IEEE P802.18 Radio Regulatory Technical Advisory Group (RR-TAG)

Proposed Response to MIIT of China Consultation on "Ultra-	
Wideband (UWB) Equipment Radio Management Regulations"

This document drafts a response to MIIT of China consultation on new UWB regulations, especially new spectrum limits. Consultation is introduced in contribution IEEE 15-23-0023-02-04ab (<u>link</u>).

Figure 1: Comparison of the power spectrum density mask between the proposed regulation of China MIIT (i.e., "Proposed mask") and the requirements defined in IEEE Std 802.15.4-2020 [1] for IEEE HRP UWB PHY channels 8 and 10 (i.e., "ch8" and "ch10").

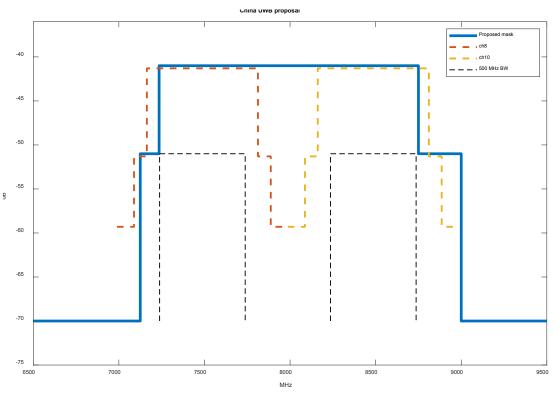
Figure 1 shows the power spectral density masks between the proposed regulation and those defined in [1] for IEEE HRP UWB PHY channels 8 and 10. Note that Channel 9 is left out intentionally to improve the clarity of the figure.

Figure 1 illustrates two issues with the proposed power spectrum density mask with respect to the IEEE Std 802.15.4-2020. First, the power spectrum density mask defined in IEEE Std 802.15.4-2020 does not fit inside the proposed limits. Secondly, the -10 dB minimum bandwidth is defined to be 500 MHz without any extra spectrum to take into account the roll-off. The figure shows that meeting the minimum bandwidth requirement (staying above the dotted black line of "500 MHz BW") and, at the same time, staying within the proposed emission limits (under blue line of "Proposed mask") using the UWB channels defined by [1], is impossible with a practical implementation.

Table 2 summarizes the IEEE 802 LMSC's proposed emission limits that allow the use of IEEE HRP UWB PHY channels 8, 9, and 10 in China.

Frequency range	EIRP limit
Below 6998 MHz	-70 dBm
6998 MHz – 7163 MHz	-51 dBm
7163 MHz – 8810 MHz	-41 dBm
8810 MHz – 8976 MHz	-51 dBm
Above 8976 MHz	-70 dBm

Figure 2: Power spectrum density of the IEEE HRP UWB PHY channel 5 with center frequency of 6489.6 MHz (i.e., "ch5") and the European band edge limits at 6 GHz (i.e., "Europe")

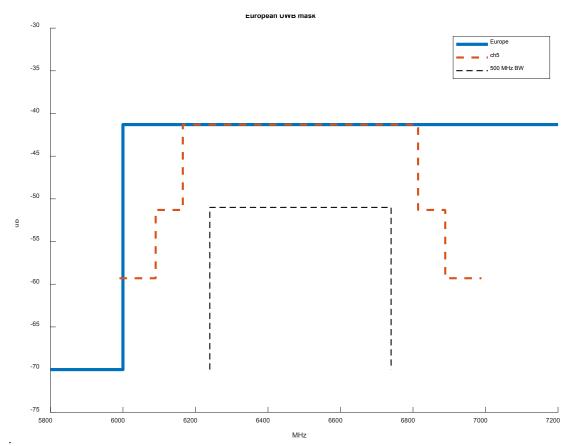
For comparison, Figure 2 shows the power spectral density mask of channel 5 and the existing European regulatory emission limits [4] at band edge. This could be used as a reference for possible limits. The European limit at 6 GHz is not very relaxed by any mean, but it does allow a feasible implementation. The 500 MHz minimum bandwidth limit is presented in the figure for reference, but it is not a requirement in Europe.

Given the center frequency of the IEEE HRP UWB PHY channel 5 is equal to 6489.6 MHz, the European rules define a frequency separation of 489.6 MHz from the center frequency to the band edge with -70 dBm limit. In order to enable use of the IEEE HRP UWB PHY channel 8 with the center frequency of 7488 MHz in China, the corresponding separation for channel 8 would require the lower -70 dBm band edge not to be higher than 6998 MHz. It is worth noticing that the -51 dBm limit does not exist in [4]. If it is considered necessary, it should not be stricter than the spectrum mask defined in the IEEE Std 802.15.4-2020, which would set the -51 dBm limit at 7163 MHz or below.

Similar expansion of the available band would be needed for the upper UWB band limit to enable IEEE HRP UWB PHY channel 10 with the center frequency of 8486.4 MHz, where a -70 limit would be set to 8976 MHz or above, and the possible -51 dB limit at or above 8810 MHz.
